Campaign Update CA#8895

Subject: Locking Hinge on the Bed Base
Affects certain 2018 Wonder W24FTB

Service Bulletin: WFTB Bed Lid Hinge Fasteners

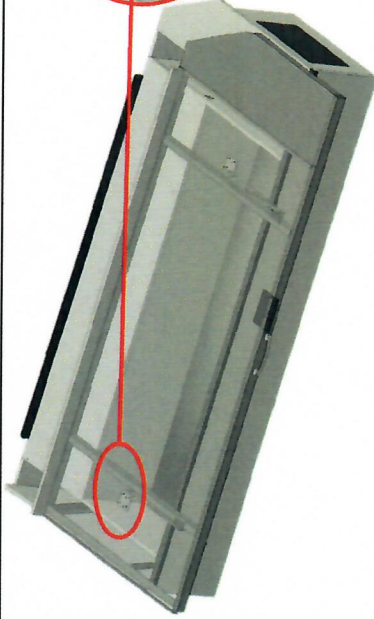
Our in-house inspections have confirmed the screws fastening the locking hinge to the bed base are incorrect. The screw type to use is a machine screw, as provided in this mailing.

Remove each of the #8 X 3/8" pan head screws from the underside of the bed lid.

In each of the predrilled holes on the lids, insert a #8X1.25" machine screw (141-0188) and washer (141-3630).

From underneath the lid, place the adjustable arm (130-0383) over the machine screws placed, along with a washer (141-3630) and nut (141-2662)

Use the 9mm wrench to hold the nut and tighten the machine screw and nut so it fits snug. Be careful not to overtighten.
